Watts Bar Nuclear Plant, Unit 2
NRC Docket No. 50-391

Subject: Watts Bar Nuclear Plant (WBN) Unit 2 – Supplemental Information For Review of Developmental Revision A of the Unit 2 Technical Specifications (TS) and Technical Specifications Bases (TS Bases)

Figure 2.1.1-1 (page 1 of 1)
Reactor Core Safety Limits

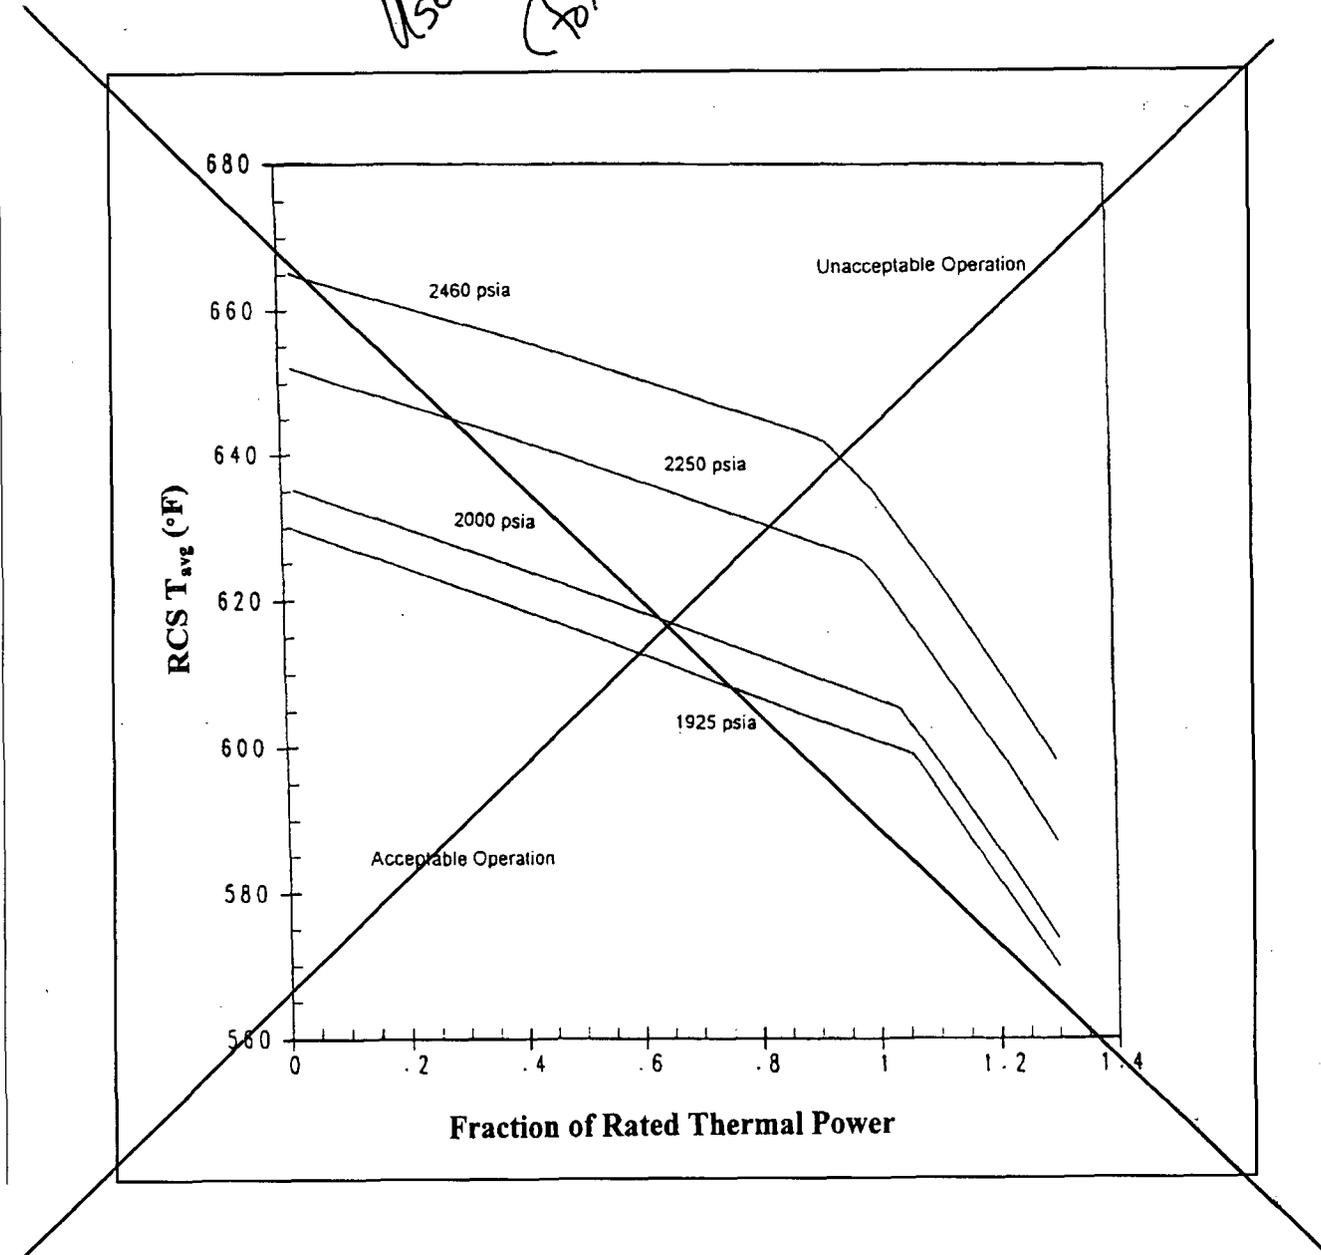
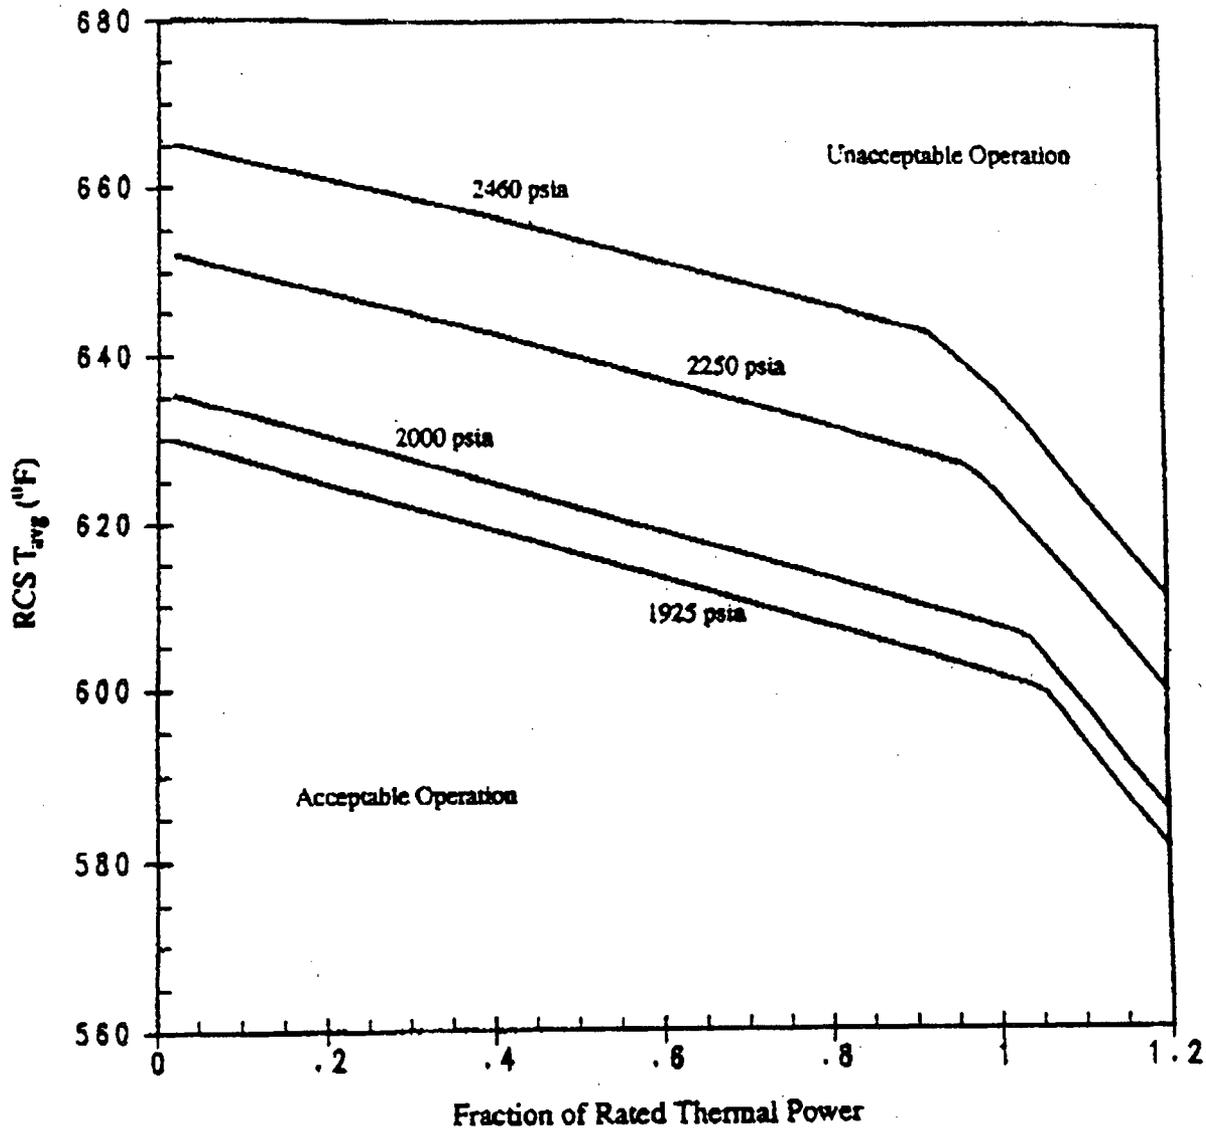
Not on U2

Use U2 Figure
(for 3411 MWt)

Not on
U2
